**METROPOLITAN GOVERNMENT OF NASHVILLE AND DAVIDSON COUNTY**

**STAFF RECOMMENDATION**  
**2204 Belmont Boulevard**  
**June 19, 2017**

**Application:** New construction-outbuilding  
**District:** Belmont-Hillsboro Neighborhood Conservation Zoning Overlay  
**Council District:** 18  
**Map and Parcel Number:** 10416035400  
**Applicant:** Sage Construction, LLC  
**Project Lead:** paul.hoffman@nashville.gov

**Description of Project:** Application to construct an outbuilding behind the principal building on this RM-20 zoned lot.

Figure 2. Front elevation of proposed DADU

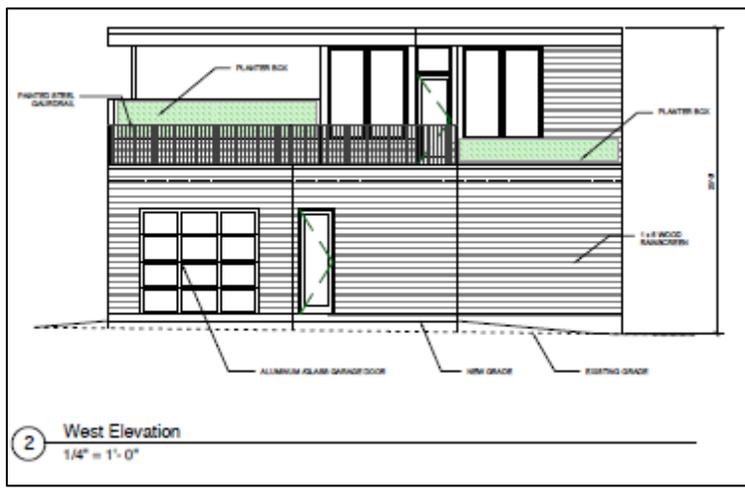
The roof form of an outbuilding is not required to match that of the house, but should have at least 4/12 pitch, according to the design guidelines. Nevertheless, flat roofed forms have been approved in the past when the building is minimally visible from the street and the overall height and massing is appropriate as the guidelines also allow for outbuildings to have a utilitarian design. Flat roofs are found on utilitarian historic outbuildings.

LANDSCAPE  
MASTER PLAN

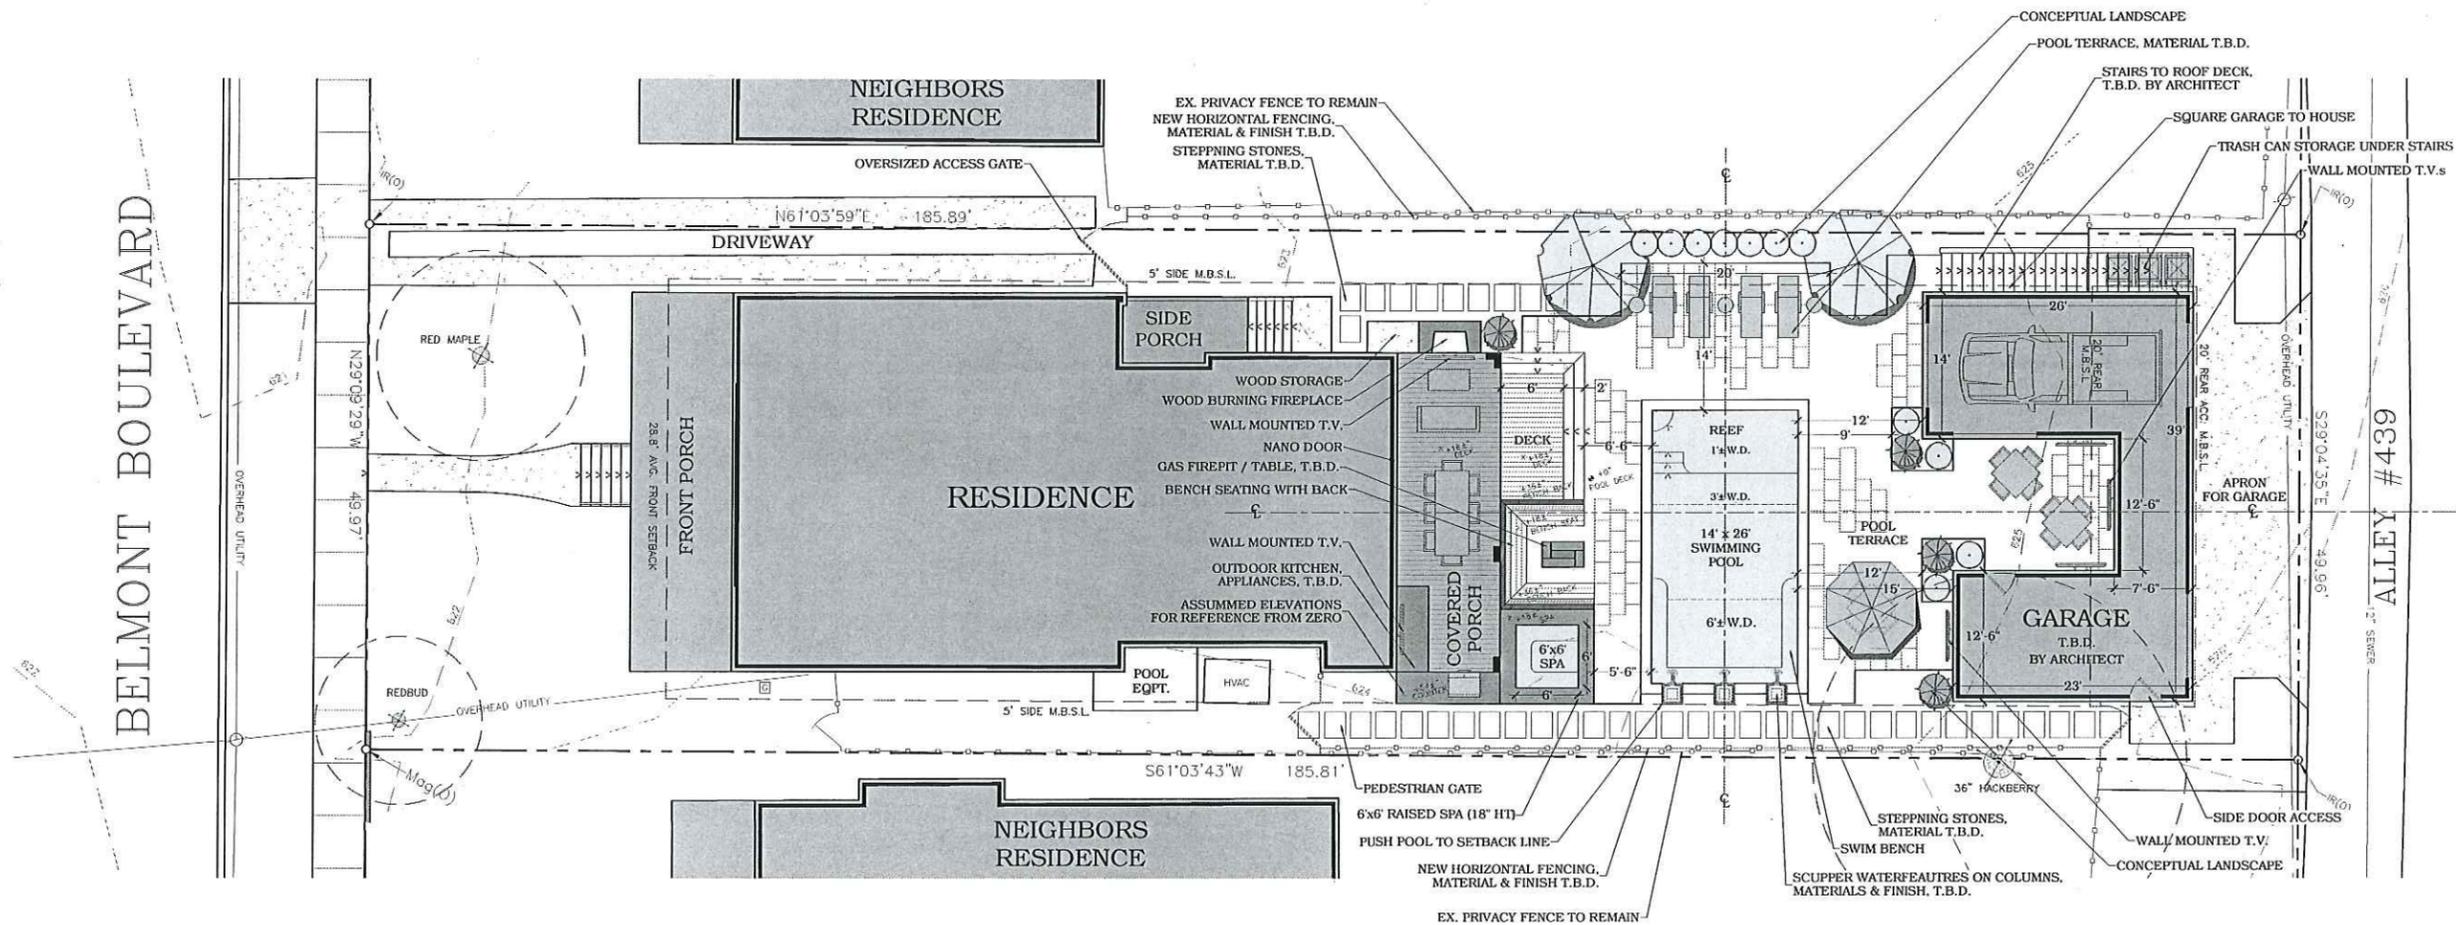
An exterior stairway was not indicated on the elevations, however the site plan shows exterior stairs on the outbuilding's right side, which would not meet the section on Character, Materials and Details. Staff recommends as a condition of approval that stairs are enclosed.

1. That stairs are enclosed; and,
2. The cladding, windows, doors, steps and planter box materials are approved prior to purchase and installation.

1 1st Floor Plan  
1/8" = 1'-0"  
746 Sq. Ft.

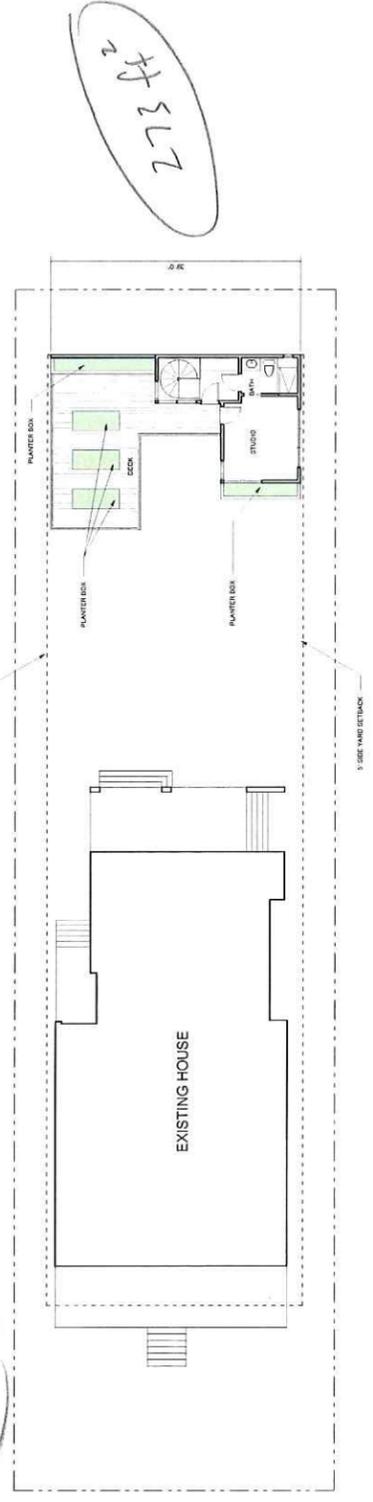
<b>Lot is less than 10,000 square feet</b>	<b>50% of first floor area of principal structure</b>	<b>Proposed footprint</b>
<b>Maximum Square Footage</b>	750 sq. ft.	1,079 sq. ft.	746 sq. ft.
